Re: Draft Major Permit Modification to Reconstruct the Suckla Farms No. 1, Weld County,
Colorado, Permit No. CO10938-02115, API No. 05-123-14291

**DRAFT MAJOR MODIFICATION
APPENDIX A CONSTRUCTION PROCEDURE**

EPA PERMIT NO. CO10938-02115

Major Permit Modification
Wattenberg Disposal, LLC, Suckla Farms No. 1 Well
Weld County, Colorado

Modified Diagram
 Suckla Farms #1 Disposal Well
 SENW, 500 feet (ft.) from the south line and 2020 ft. from the west line, Section 10,
 Township 1 North, Range 67 West, Weld County, Colorado
 API No. 05-123-14291

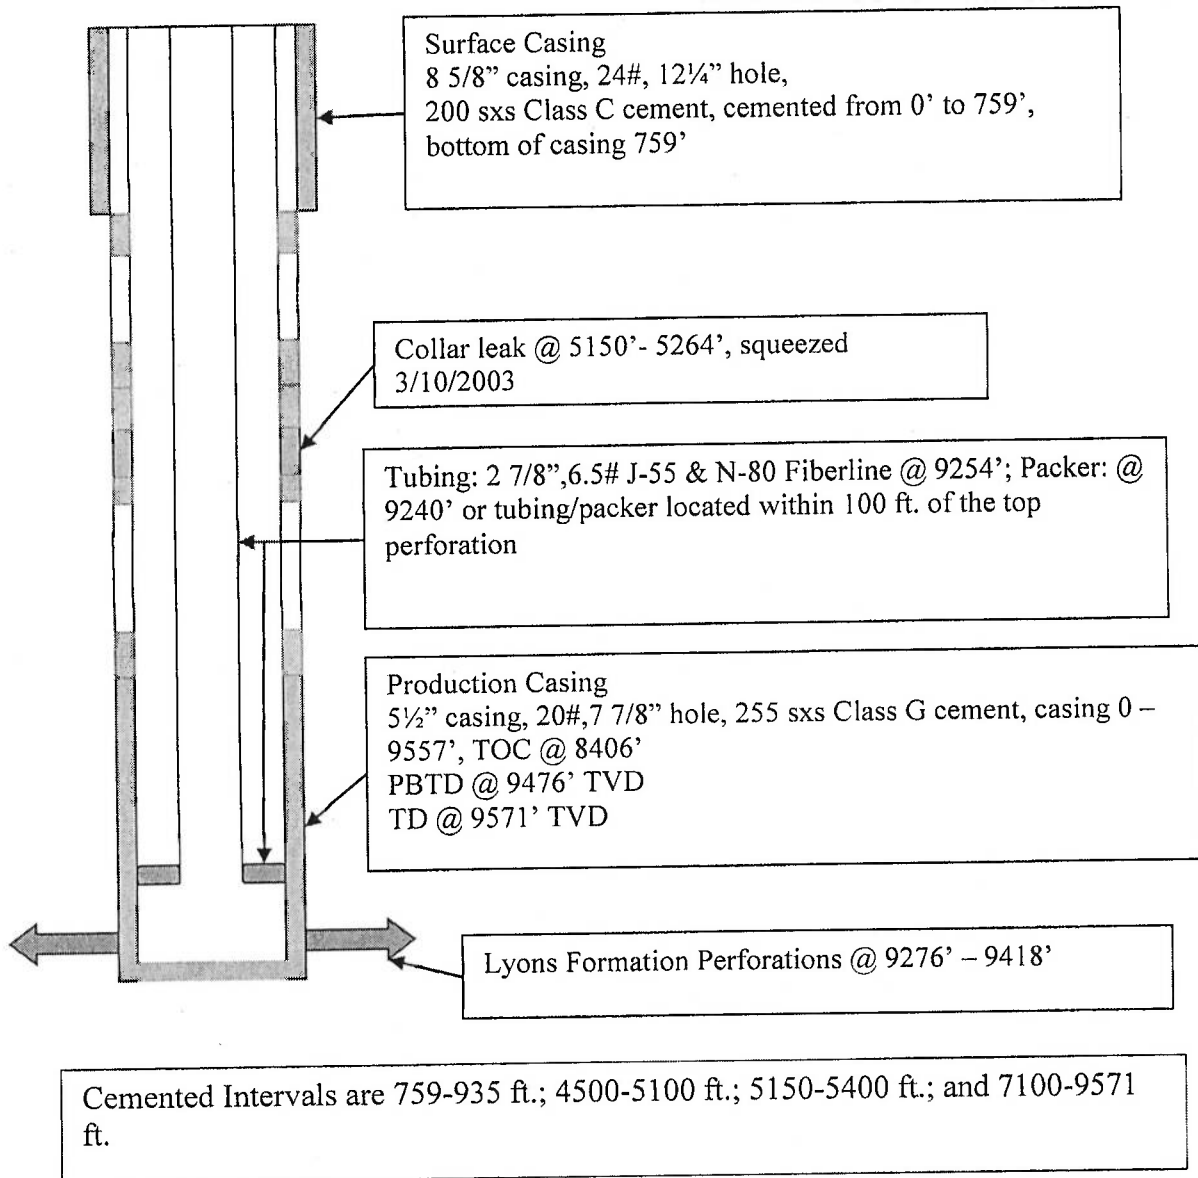
Wattenberg Disposal LLC wishes to squeeze cement behind the currently uncemented production casing of the Suckla Farms #1 well. Apparently, Anadarko Petroleum is wanting to hydraulically fracture a nearby production well at intervals shallower than the existing top of cement behind the Suckla Farms #1 production casing.

For reworks, the recently issued permit, CO10938-02115, at section II(A)(6) requires compliance with all conditions in the permit and section II(A)(1) refers to the Appendix A well construction including the wellbore diagram and construction description. Newly added cement behind the production casing obviously does not appear in Appendix A because it does not yet exist.

Following our discussion yesterday during the Tech Mtg, this seems to be an example where a permit modification is needed because the well's construction will be changed, and this is taking place long after the "during construction" phase of the well, described in 144.52(a)(6). I believe this will have to be a major mod as a result. If you have a different understanding or interpretation, please let me know. Seems like Wattenberg is in a hurry.

Stage	Procedure	Comments	Time [hours]
Rig Move	MIRU		4
	NU		2
	Set BOP		2
	Rig Crew travel		
Preparation	Lay-down fiber-lined tubing		16
	Pick-up work string	Bit and scraper	1
	Tag bottom, TOH		8
Squeeze Niobrara	RIH Wireline shoot perforations for squeeze job	Nio: 7100'-8406'	6
	RIH work string and 32A packer	Hydro test. Set packer 200' above perfs	4
	Test packer and casing. Establish Injection rate		2
	Squeeze Niobrara, displace cement	220 sx	4
	TOH		
Test Niobrara	RIH with cone bit, drill excess cement		4
	Test squeeze job		2
	TOH		4
Squeeze Sussex 1	RIH Wireline shoot perforations for squeeze job	Sussex 1: 5200'-5400'	6
	RIH work string and 32A packer	Hydro test. Set packer 200' above perfs	4
	Test packer and casing. Establish Injection rate		2
	Squeeze Niobrara, displace cement	30 sx	4
	TOH		
Test Sussex 1	RIH with cone bit, drill excess cement		4
	Test squeeze job		2
	TOH		4
Squeeze Sussex 2	RIH Wireline shoot perforations for squeeze job	Sussex 2: 4700'-5100'	6

RIH work string and 32A packer	Hydro test. Set packer 200' above perfs	4
	Test packer and casing. Establish Injection rate		2
	Squeeze Niobrara, displace cement	70 sx	4
	TOH		
Test Sussex 2	RIH with cone bit, drill excess cement		4
	Test squeeze job		2
	TOH		4
Squeeze Sussex 3	RIH Wireline shoot perforations for squeeze job	Sussex 3: 4500'-4600'	6
	RIH work string and 32A packer	Hydro test. Set packer 200' above perfs	4
	Test packer and casing. Establish Injection rate		2
	Squeeze Niobrara, displace cement	20 sx	4
	TOH		
Test Sussex 3	RIH with cone bit, drill excess cement		4
	Test squeeze job		2
	TOH		4
TOTAL			137
